Before a Board of Inquiry
MacKays to Peka Peka Expressway Proposal

in the matter of: Notice of requirement for designation and resource consent applications by the NZ Transport Agency for the MacKays to Peka Peka Expressway Proposal

Statement of rebuttal evidence of **Siiri Wilkening** (Operational Noise) for the NZ Transport Agency

Dated: 24 October 2012

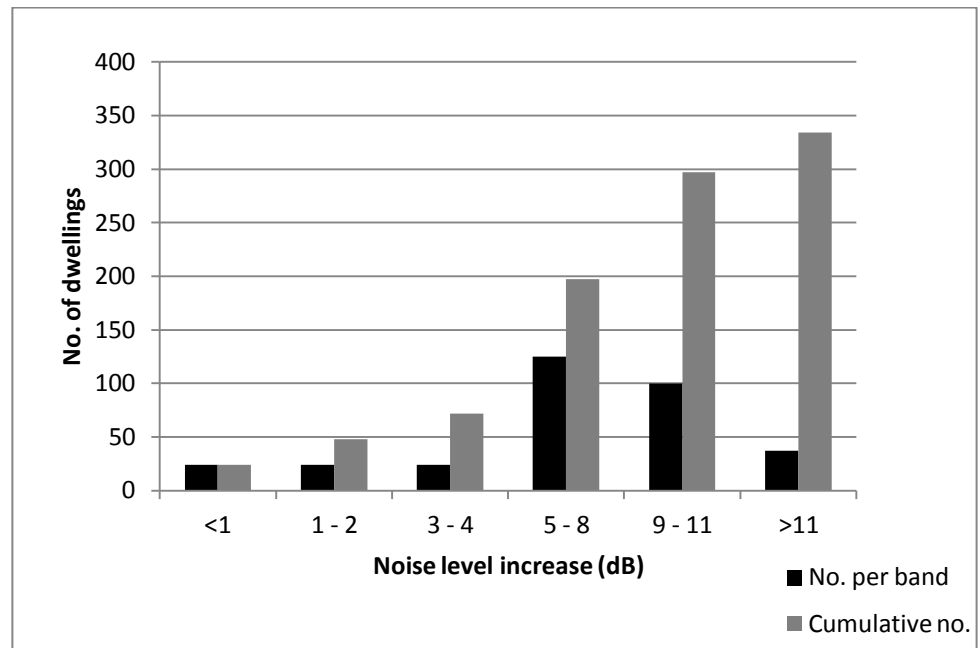
- 38 In his evidence, Mr Hunt makes some statements regarding the increase in noise levels and provides a cumulative data set²⁷ based on the tables contained throughout Section 7 of Technical Report 15. However, interpretation of the data is not correct. The figure below shows the same cumulative dataset as shown in Mr Hunt’s

evidence (in grey), and I have added (in black) the number of dwellings in each of the noise level bands.

39 Mr Hunt states that “over half of affected PPFs will receive an increase in existing ambient sound levels by 9 dBA or more”.²⁸ In fact, around 40% of PPFs (137 of 334) are predicted to receive a noise level increase above 9 decibels. The band of noise level increase with the highest number of PPFs is predicted to be between 5 to 8 decibels (as shown in the figure above).
